Change Notice

SK Series

Subminiature Antistatic Process Sealed Keylocks Terminal Plating from Tin to Gold

Terminal Surface Finish

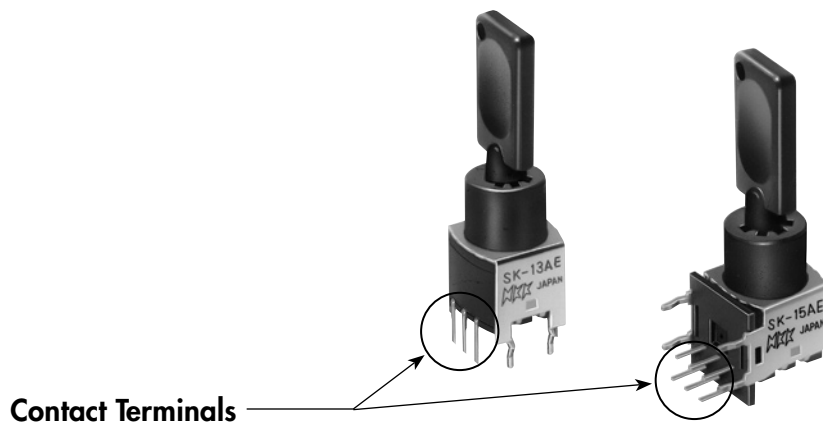
The entire SK Series with the 9mm diameter smooth bushing (E code) now has an improved surface finish to the contact terminals. This change includes all standard parts as well as related custom devices.

FROM	TO
Tin (Sn-Cu) Plating over Nickel (Ni) Plating	Gold Plating (Au) over Nickel (Ni) Plating

SK Series Keylocks with new terminal plating will be effective with February 2008 production.
